Access Compliance Report

Public Rights-of-Way

(Curb Ramps)

Intersection ID: 52442	Main Street: WOODWARD_AV	Cross Street: BENDING_BIRCH_PL	Location: W
ADA ID: A402F4F6FD52	Ramp Type: Directional1	Initial Pass/Fail: Pass	Overall Compliance: No
			Severity Score: 20.25

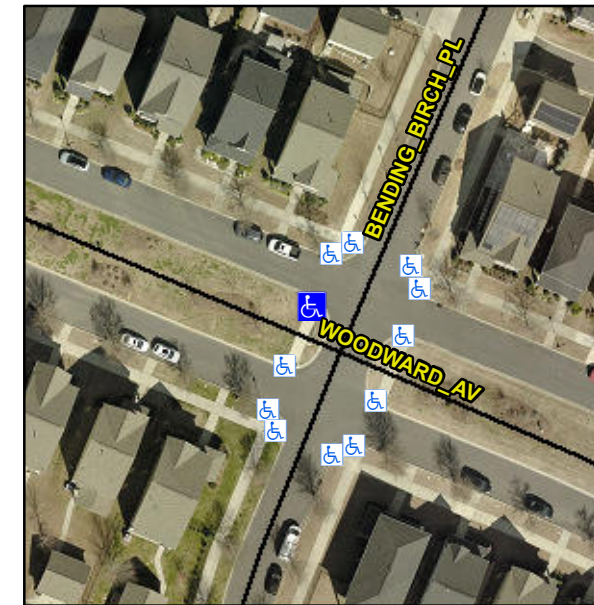
LOCATED ON MEDIAN

R304.5.3, R302.7.2, R304.5.4

Compliance	Description	Data	Compliance	Description	Data
N/A	Ramp Length (in)	85.5	Yes	Grade Break?	Yes
Yes	Ramp Width (in)	60.0	No	Grade Break Slope (%)	5.4
Yes	Ramp Slope (%)	7.0	Yes	Grade Break XSlope (%)	3.3
Yes	Ramp XSlope (%)	2.1			
Yes	Flare Type LT	N/A	Yes	Flare Type RT	N/A
N/A	Flare Slope LT (%)	N/A	N/A	Flare Slope RT (%)	N/A
N/A	Flare Traversable LT?	No	N/A	Flare Traversable RT?	No
Yes	Landing Length (in)	72.0	Yes	DWS Provided?	Yes
Yes	Landing Width (in)	72.0	Yes	DWS Contrast?	Yes
Yes	Landing Slope (%)	0.3	Yes	DWS Length (in)	24.0
Yes	Landing X Slope (%)	1.0	Yes	DWS Full Width?	Yes
N/A	Landing Curb? (Y/N)	N/A	Yes	DWS Offset LT (in)	0.0
N/A	Shared Landing?	No	Yes	DWS Offset RT (in)	13.0
Yes	Gutter Ponding?	No	No	Gutter Slope (%)	8.0
No	Gutter Lip Ht (in)	1.0	Yes	Gutter X Slope (%)	3.4
N/A	Painted X Walk1?	No		Road Slope (%)	2.3
	X Walk 1 Direction	To N		Road X Slope (%)	5.2
	X Walk 1 Width (in)	N/A		Clear Space?	Yes

**Remove & Replace Entire Ramp.
Remove & Replace Gutter.**
